DEVELOPMENT ASSESSMENT REPORT

Application No.	DA/2020/0510
Address	217 Albany Road STANMORE NSW 2048
Proposal	Alterations and additions to existing dwelling including a garage with studio above at the rear of the site.
Date of Lodgement	03 July 2020
Applicant	Innovac Dyer Architects
Owner	Ms Channelle V Jacob
Number of Submissions	No submissions
Value of works	\$46,500.00
Reason for determination at Planning Panel	Clause 4.6 variation exceeds 10%
Main Issues	FSR
Recommendation	Approval
Attachment A	Recommended conditions of consent
Attachment B	Plans of proposed development
Attachment C	Clause 4.6 Exception to Development Standards

scale: 1:50 @A3
drawn: B. Dyer B.Arch
date: 1st Nov, 2020
DWG NO. **DA5A**

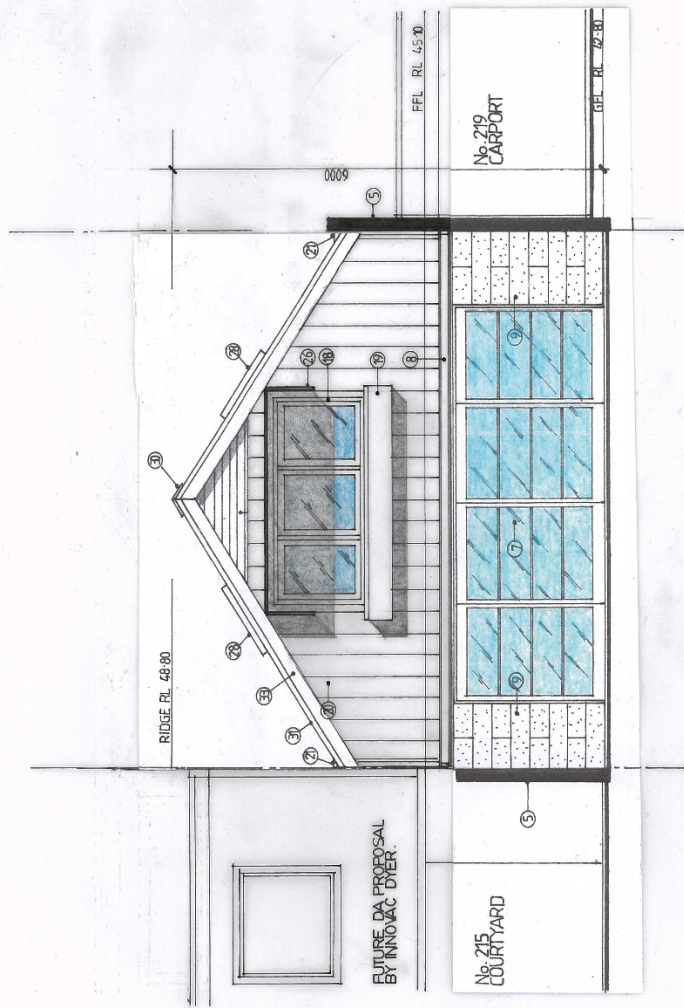
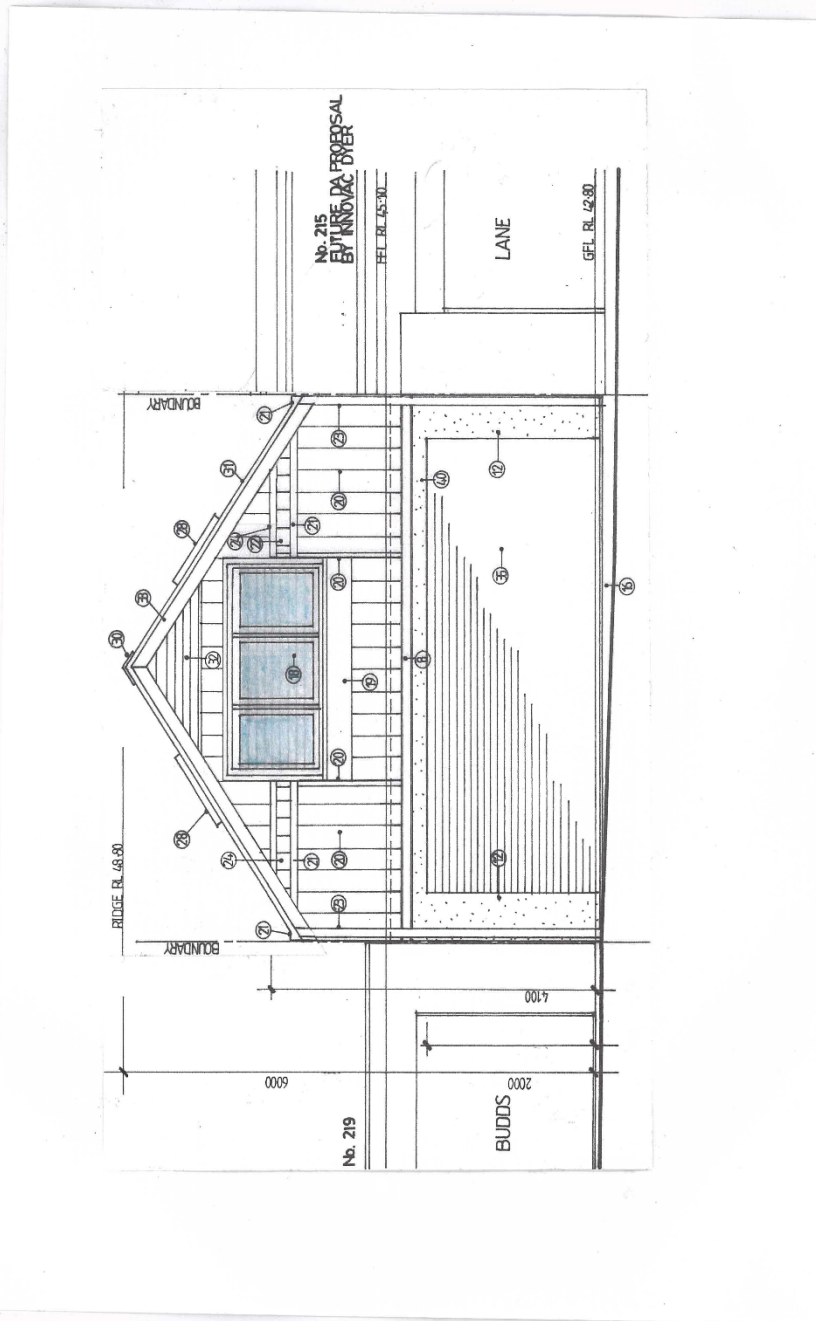
Amendments A. Roof ridge lowered by 1000mm. Garage ceiling lowered
PROPOSED FIRST FLOOR ADDITION & ALTERATIONS TO AN EXISTING REAR LANE GARAGE AT 217 ALBANY RD STANMORE
DRAWING TITLE: **NORTH ELEVATION**

Prior to the issue of a Construction Certificate, the Certifying Authority is required to be provided with amended plans with each plan identifying the ridge RL to be 48.80.

scale: 1:50 @A3
drawn: B. Dyer B.Arch
date: 1st Nov 2020
DWG NO
DA 6 A

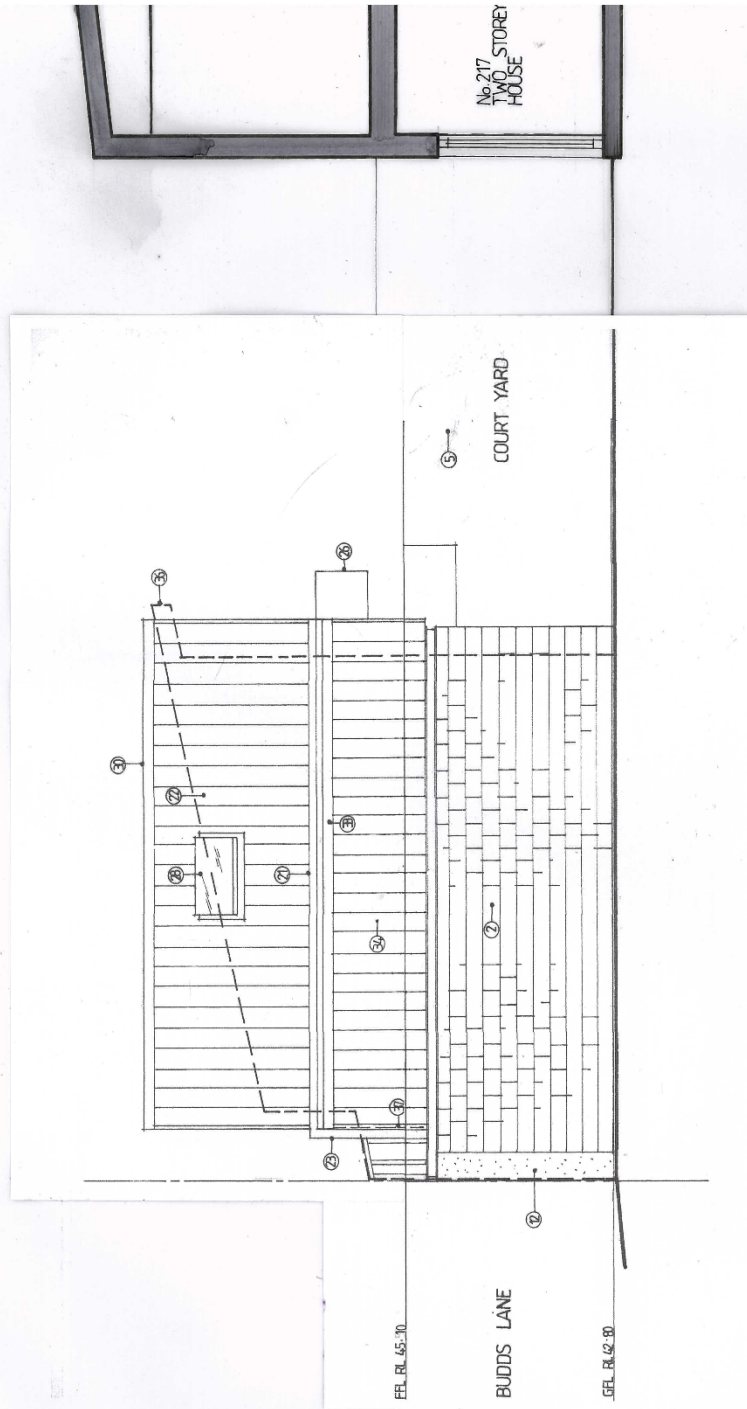
Amendments A. Roof ridge lowered by 1000mm. Garage ceiling lowered
PROPOSED FIRST FLOOR ADDITION & ALTERATIONS TO AN EXISTING REAR LANE GARAGE AT 217 ALBANY RD STANMORE
DRAWING TITLE: **SOUTH ELEVATION**

scale: 1:50 @A3
 drawn: B. Dyer, B.Arch
 date: 1st Nov 2020
 DWG NO
DA7 A

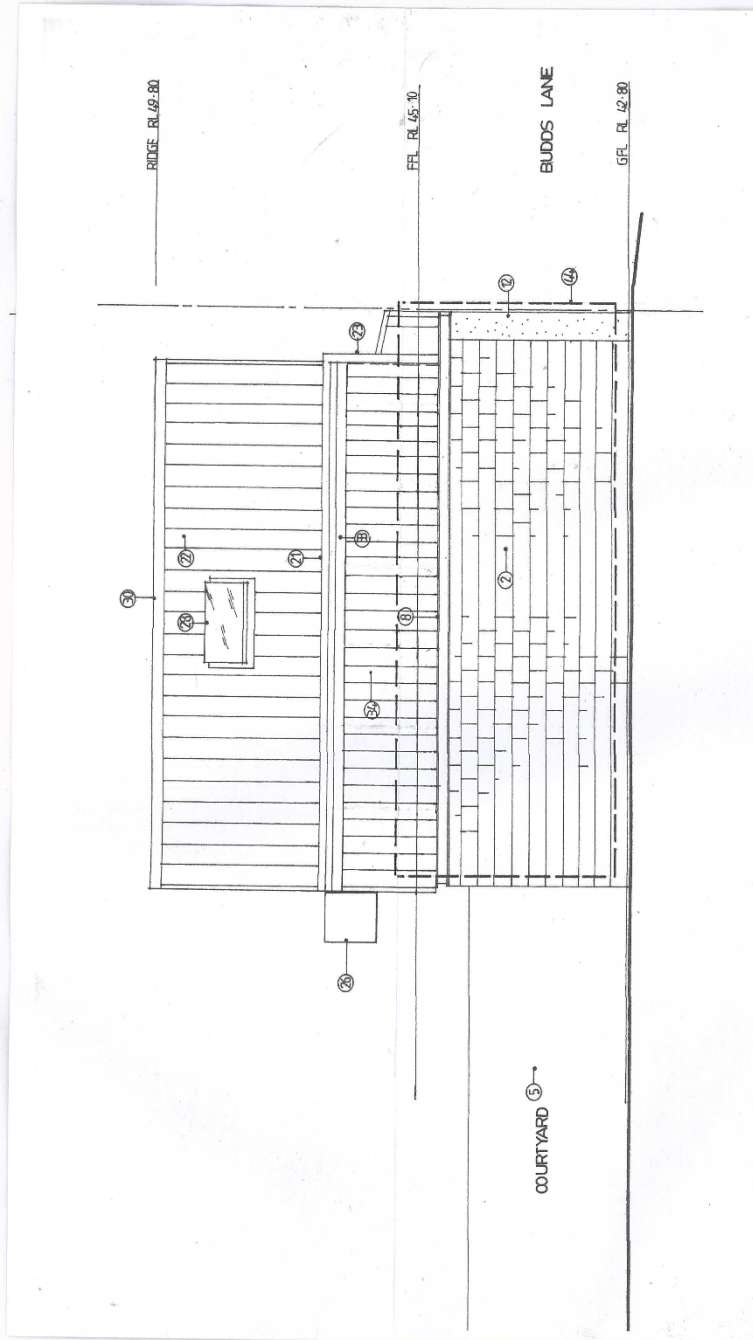
Amendments A Roof ridge lowered by 1000mm. Garage ceiling lowered East and West Elevations showing weatherboards.
PROPOSED FIRST FLOOR ADDITION & ALTERATIONS TO AN EXISTING REAR LANE GARAGE AT 217 ALBANY RD STANIMORE
 DRAWING TITLE: **EAST ELEVATION**

scale: 1:50 @A3
 drawn: B. Dyer B.Arch
 date: 1st Nov. 2020
 DWG NO. **DA9 A**

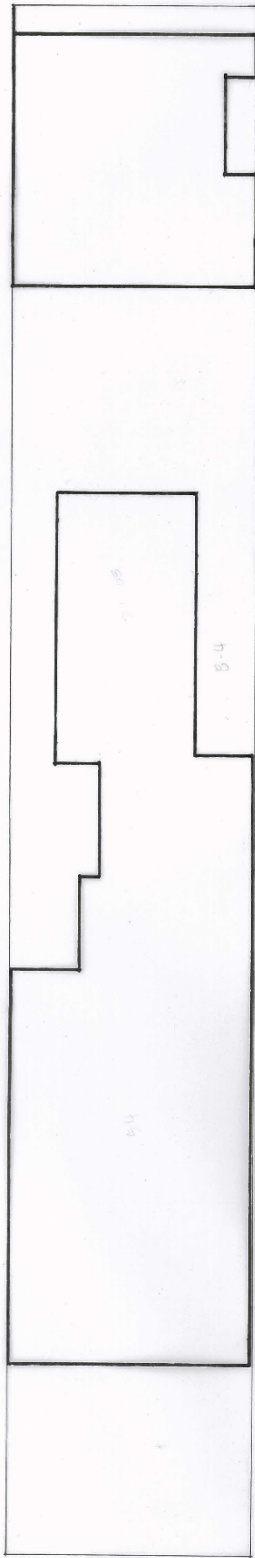
Amendments: A. Roof height lowered. Garage ceiling height lowered.
PROPOSED FIRST FLOOR ADDITION & ALTERATIONS TO AN EXISTING REAR LANE GARAGE AT 217 ALBANY RD. STANMORE
 DRAWING TITLE: **CROSS SECTION**
